CONSTRUCTION OF OIL JETTY
NO. OJ 8 AND OJ 9
AT OLD KANDLA

Project Title: Design, Supply, Installation, Testing & Commissioning of Fire-fighting system and associated facilities including Operation & Maintenance for a period of five years as per OISD-156 at Oil Jetty No. 08, Kandla, of Deendayal Port Authority

Annexure-A

Project Title- Design, Supply, Installation, Testing & Commissioning of Fire-fighting system and associated facilities including Operation & Maintenance for a period of five years as per OISD-156 at Oil Jetty No. 08, Kandla, of Deendayal Port Authority

OIL JETTY - OJ 8
MARINE LAYOUT

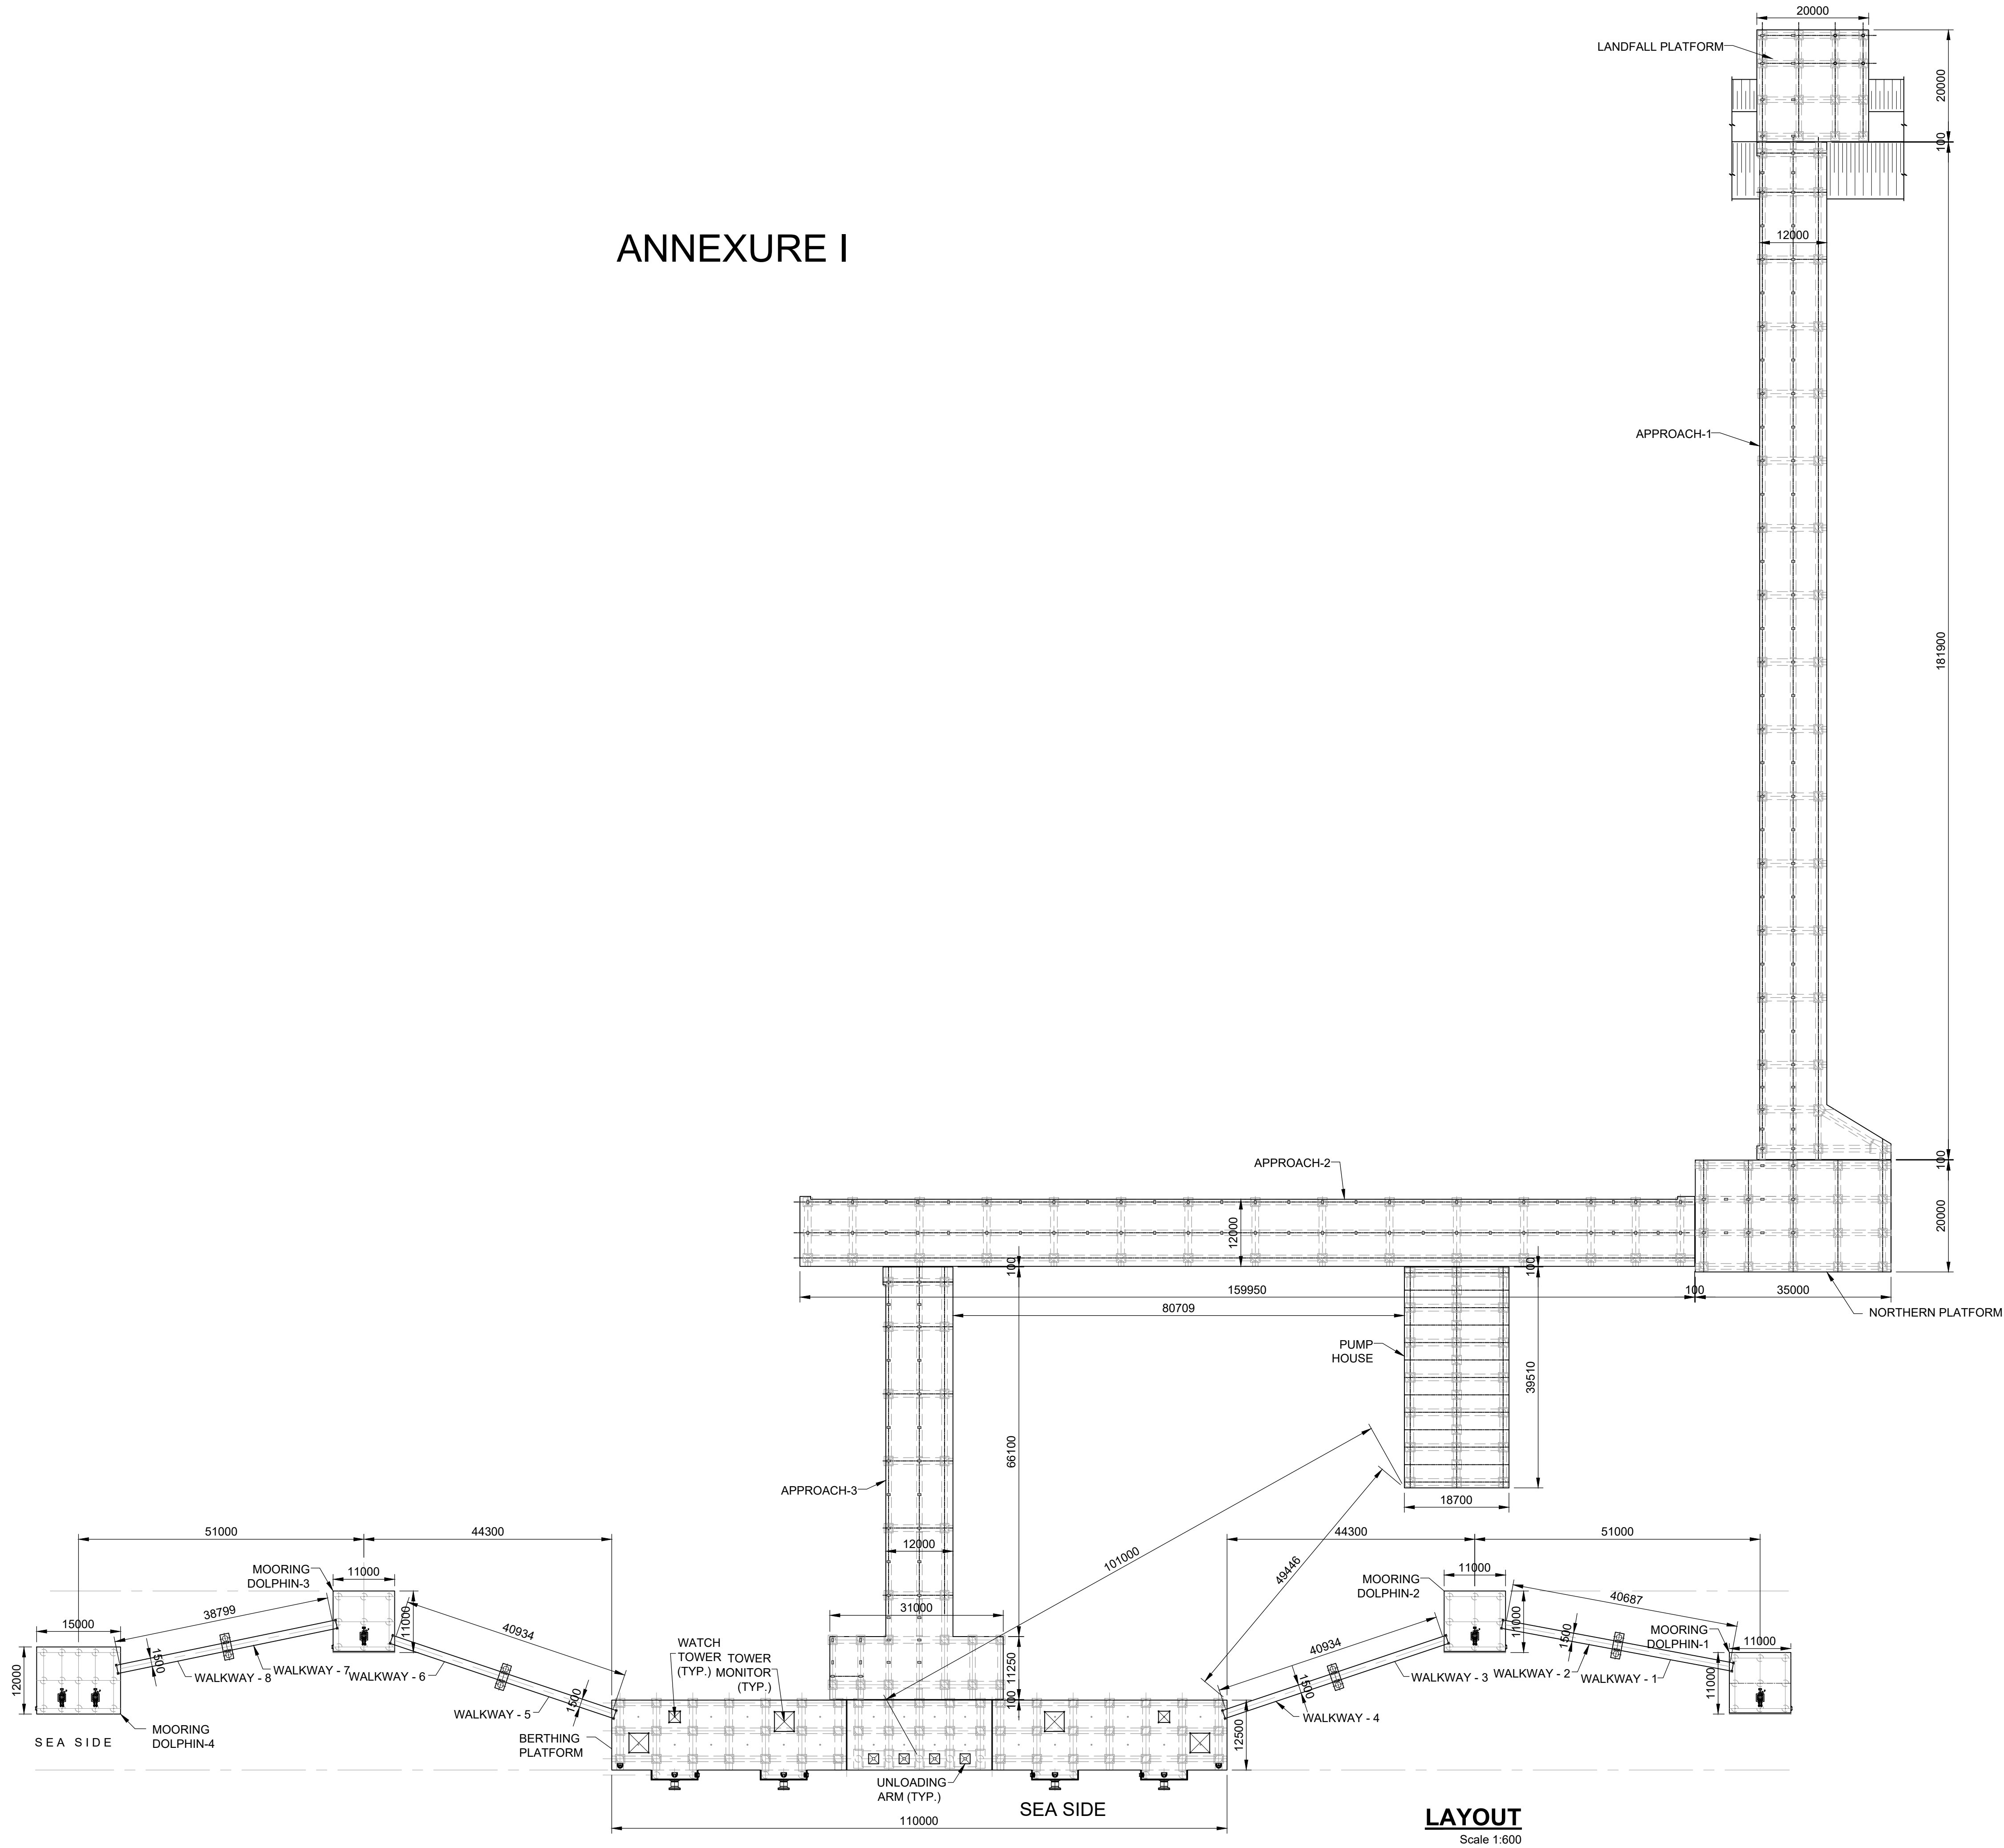
SL.No	Ref: Tender Clause No.	Bidder's Queries	DPA's Clarification
1	NA OJ Layout main drawing	Drawing- Kindly share the readable layout of the complete Oil jetty No.8 (OJ 08) drawing showing the jetty berth, jetty approach road, proposed location of the pump house, substation, etc., along with the dimension and with the scope demarcation.	The details have been attached at Annexure I.
2	Vol -II of CL.No.5.3.32 (Page No.61)	The control room shall have emergency power fed by DG. We understand that the Substation with Emergency DG Set will be in DPA scope . Bidder need to lay the power cable from Substation to Control Room only. Kindly confirm our understanding	The DG set, if required, shall be under DPA scope.
3	Vol-I Appendix -5 CL.No.3 (Page No.112)	Performance Guarantee Parameters. We understand the parameters defined in this Appendix are not related to Fire Protection System and hence Not Applicable . Kindly confirm our understanding .	Revised Appendix -5 has been attached.
